DESIGN REVIEW BOARD – URBAN DESIGN PANEL

September 1st, 2022

**Planning Staff Report to
Design Review Board - Urban
August 15, 2022
for the September 1, 2022 Public Hearing**

CA 22-363 • 912 SOUTH MAIN STREET

A1
A010 SITE PLAN
1/16" = 1'-0"

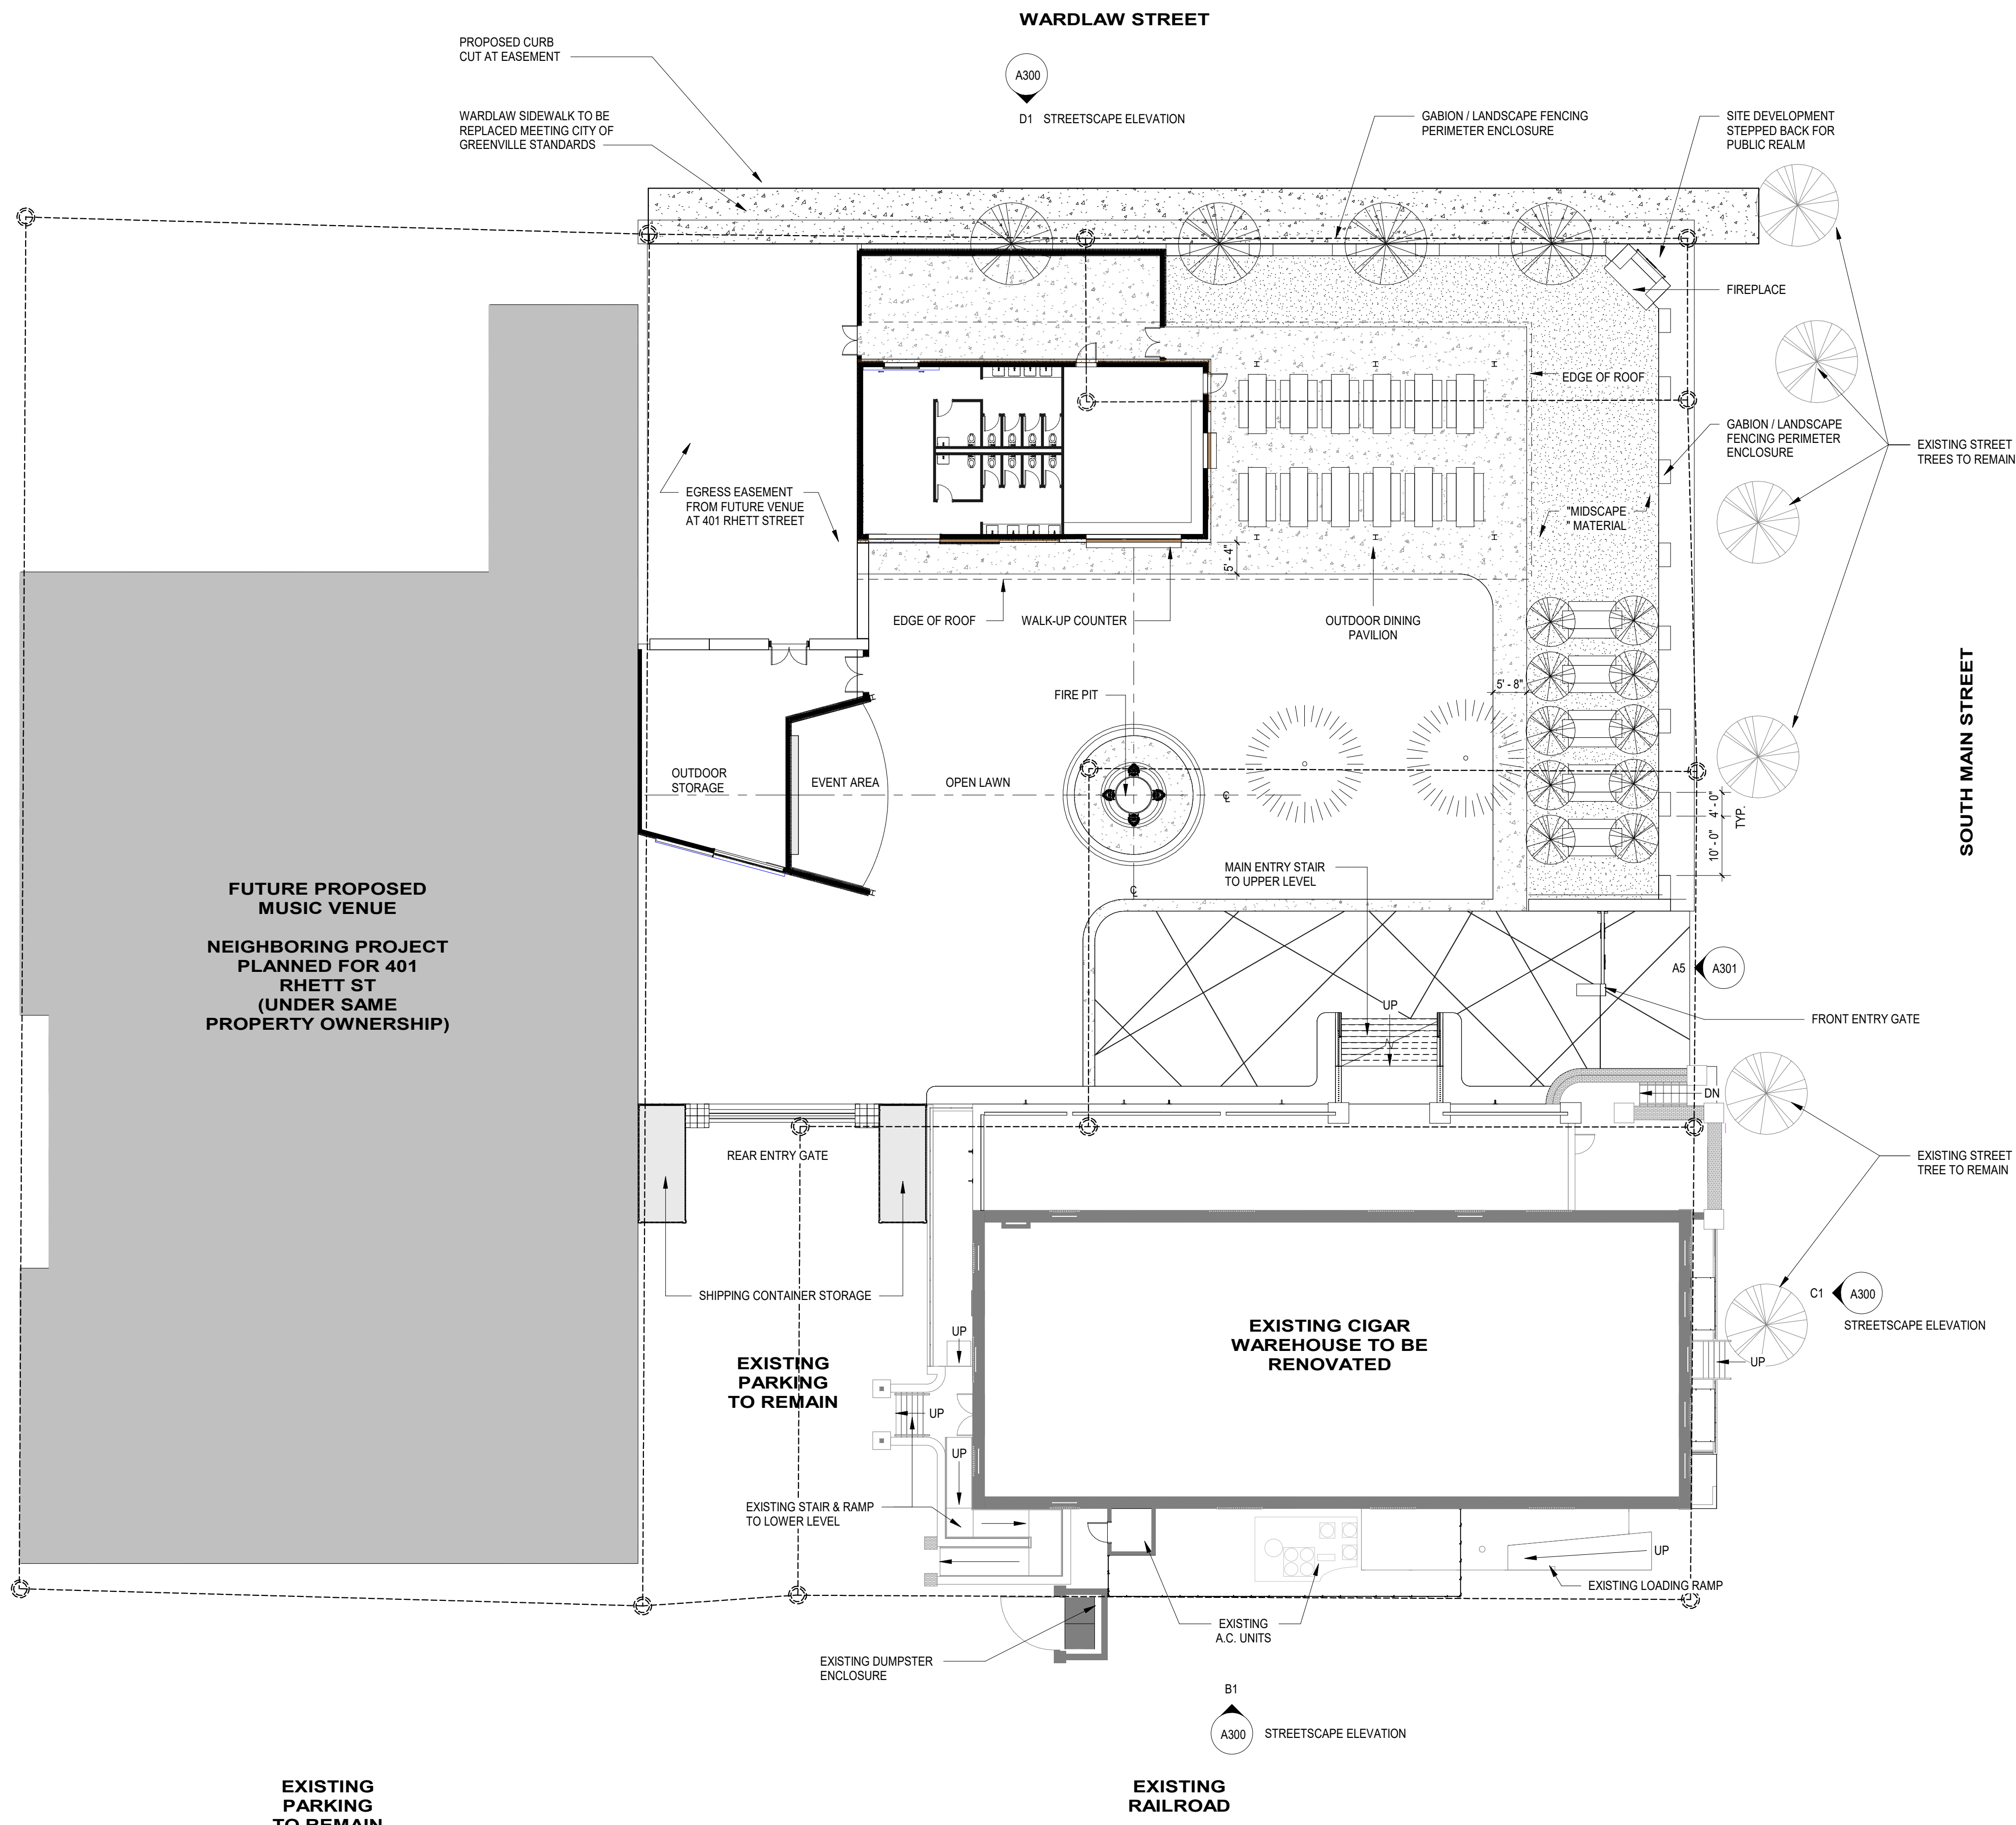
- No bike racks are proposed in the provided plans
 - Staff recommends incorporation of bike racks into the site plan per PRI 1.3.
- PRI 3 – Entry
 - The proposed plans indicate two primary entrances into the site – one at the existing building entry along Main Street, and a second gated entry into the outdoor entertainment space directly adjacent to the building.

- Staff also notes that the use of shipping containers as storage units as shown in the site plans is not acceptable per PRI 6.1.
- PRI 7 – Architectural Lighting

5. A minimum of two bike racks shall be provided in a safe, convenient, and well-lit location per PRI 1.3.
6. In lieu of the proposed shipping containers to be used for storage, the applicant shall work with staff to provide enclosures consistent with the existing and proposed architecture's materiality.

C1
A300
SOUTH MAIN STREET ELEVATION
3/32" = 1'-0"

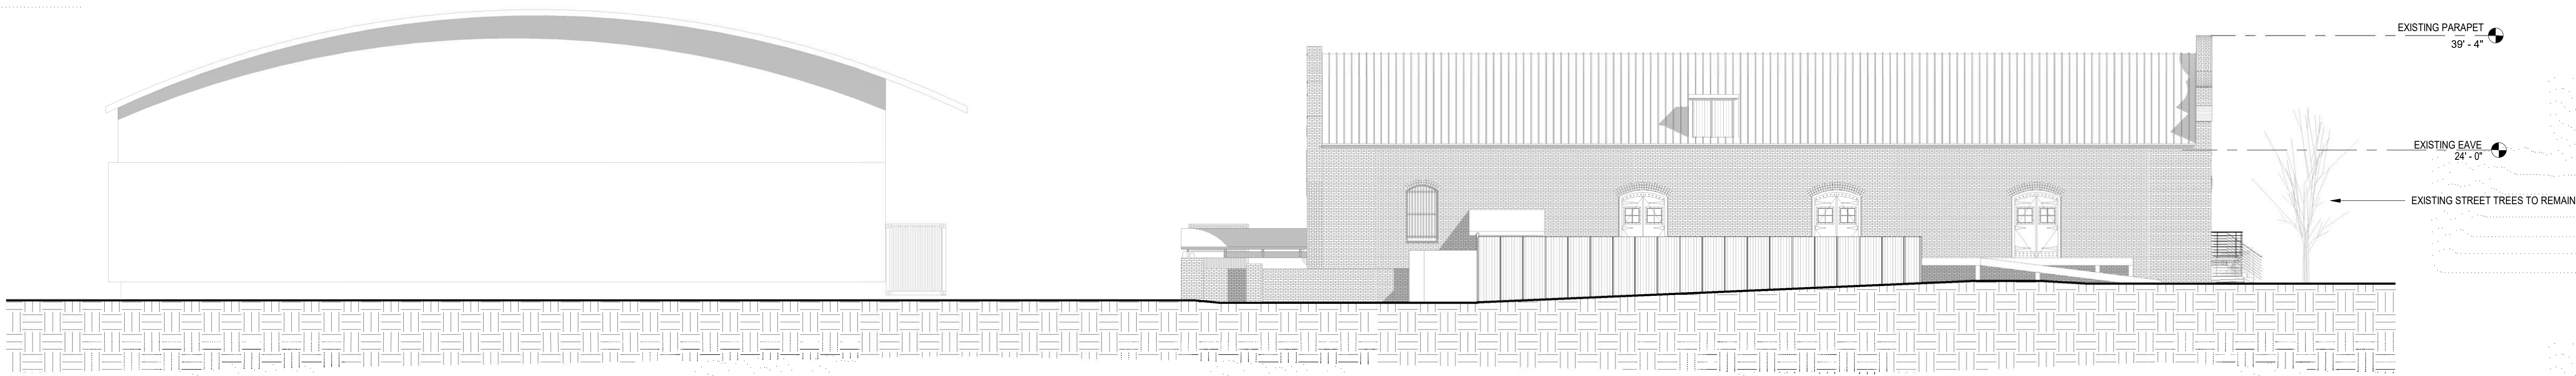
- Remove a portion of the western elevated landing.
 - Staff finds that most of the proposed alterations to the existing structure are acceptable and preserve the architecture's original and important features; however, the proposed steel balconies on the Main Street façade detract from the building's character and frontage along Main Street. Staff also notes that no access to these spaces is indicated in the architectural plans.

7. The proposed balconies on the Main Street façade of the main building shall be removed from the proposed plans. No changes to the existing windows are approved.

D3 FIREPLACE SOUTH ELEVATION
A301 1/4" = 1'-0"

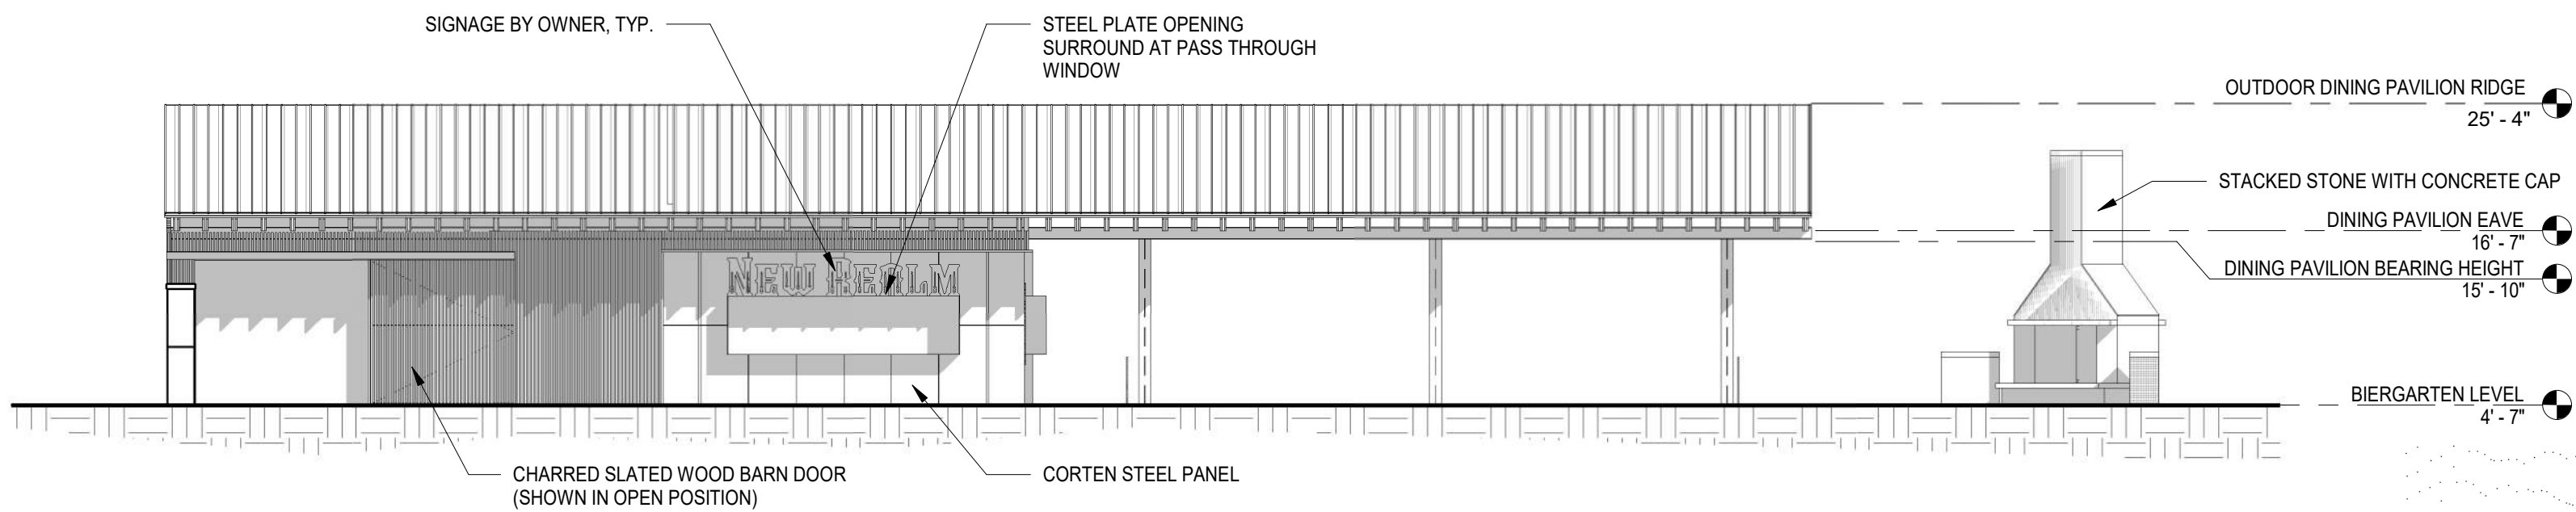
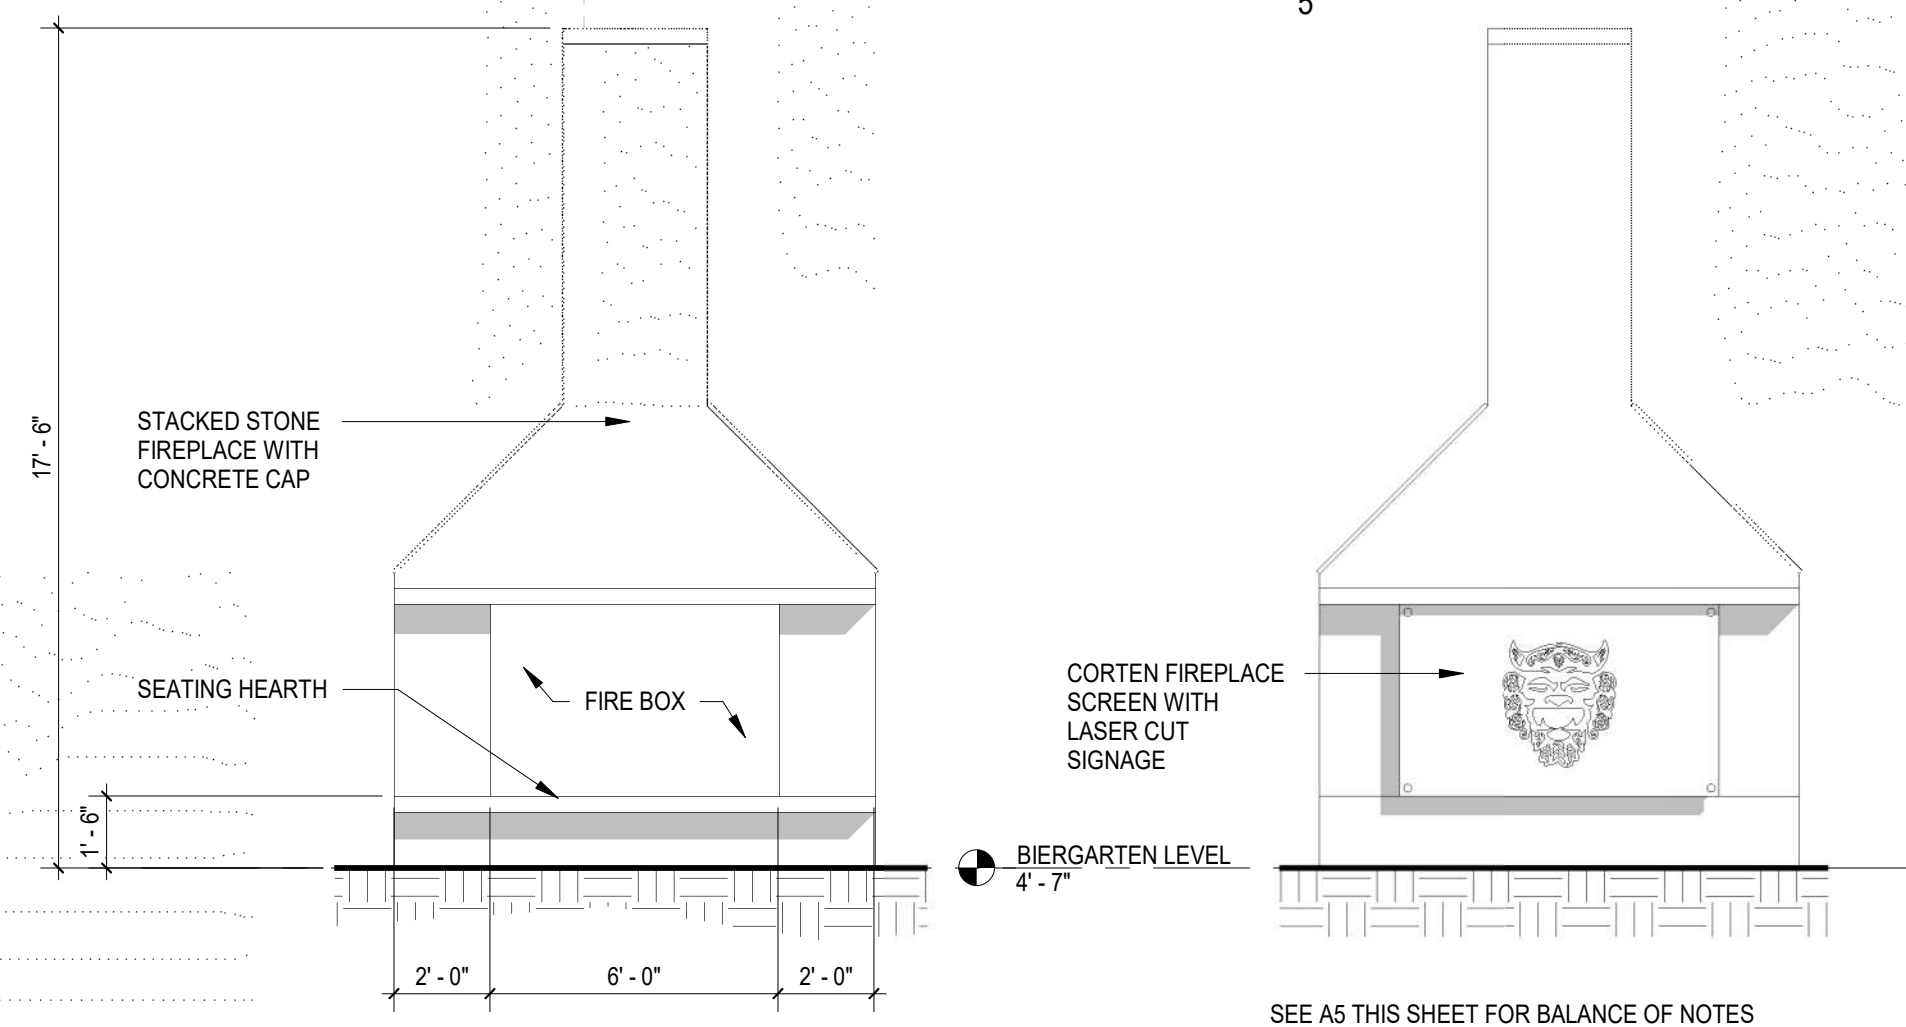
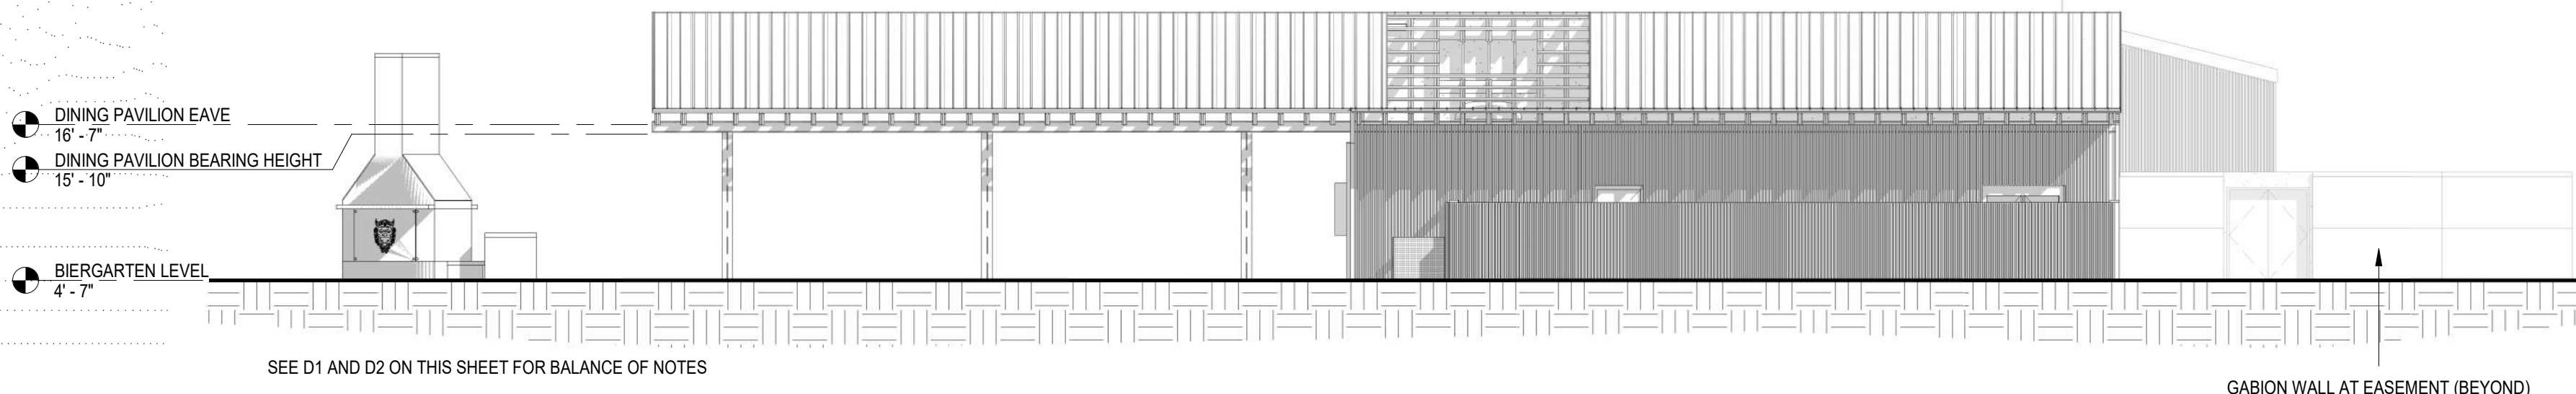
- PUB 10 – Walls, Fencing, and Screening
 - A series of gabion segment walls are proposed to provide privacy and enclosure along the edges of Main and Wardlaw Streets, and a stacked stone fireplace is proposed at the primary corner of the site. Per PUB 10.4, walls and fences should complement the architectural character of adjacent buildings and appear as extensions of building walls and bases. The materiality and detailing of the walls and fireplace as proposed do not complement the existing brick structure.

- Staff recommends modification of the fireplace and wall materials to match the existing building. The brick wall around the perimeter of the site should match the existing brick wall adjacent to the Cigar Warehouse for consistency and to minimize multiple competing materials.
